# Review of the OPW cost estimate Little Island Tidal Barrier Cork

April 10<sup>th</sup>, 2018  
Final

W.F. Molenaar M.Sc.  
Prof. S.N. Jonkman

Figure: Actual and predicted costs of storm surge barriers (from Mooyaart and Jonkman (2017)) with the bandwidth added with blue lines.

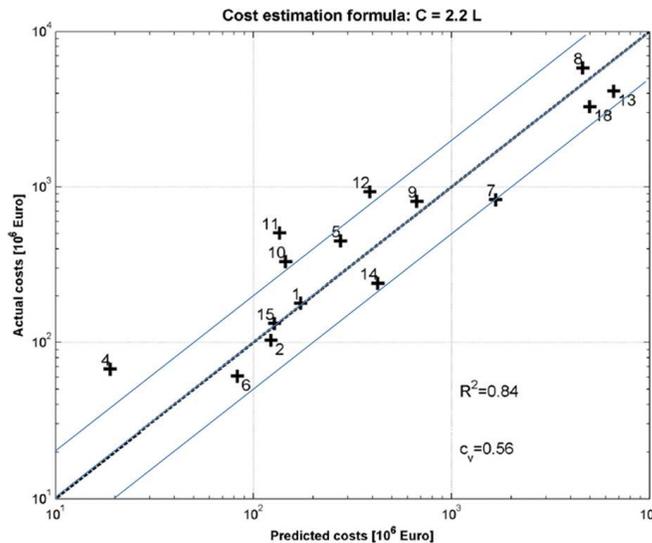
The unit cost estimates from Mooyaart and Jonkman (2017) are associated with a considerable bandwidth and are therefore most useful to give an estimate of the order of magnitude of costs in the planning and screening phase. On average, the unit cost for a storm surge barrier was found to be €2.2 million per meter of span. The coefficient of variation is 0.56 and most of the observed costs are within a factor 2 of the prediction formula (see figure below).

Figure illustrating/clarifying the term cumulative span from Mooyaart and Jonkman (2017)

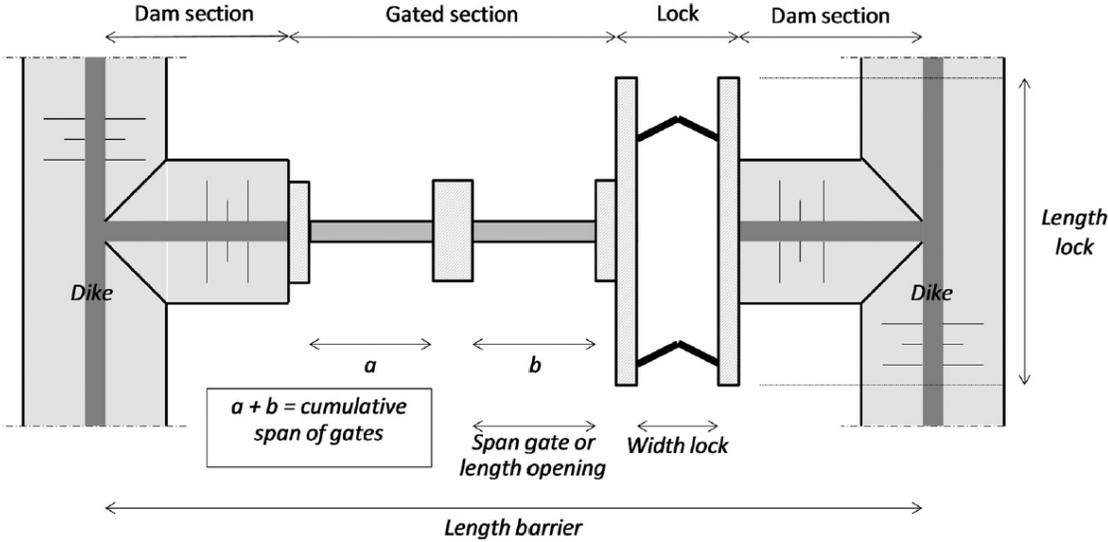
Unit cost estimates for storm surge barriers in Mooyaart and Jonkman (2017) are derived as a unit cost based on the length of the gated elements of the barriers (indicated as cumulative span in the clarifying figure in Appendix 2). These costs are "all-in" and do include the costs of impounding / connecting
